Notice 98-002

It has come to the attention of the Foundation from field reports that there was a change in the design of the check valve poppets contained in the following assemblies:

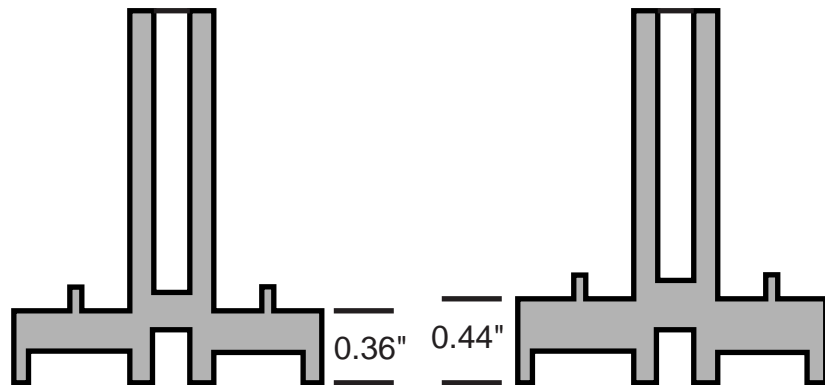
The thickness of the check valve poppet was found to be greater than the originally submitted and approved configuration. See detailing below:

The thicker poppet will not affect the assembly's ability to prevent backflow but it will cause a higher overall pressure loss, and for some models and sizes the maximum allowable pressure loss may be exceeded. Production units affected will have serial numbers between #566393 to #644281.

Should you have any assembly affected by this modification, contact Wilkins Regulator Company for replacement components.
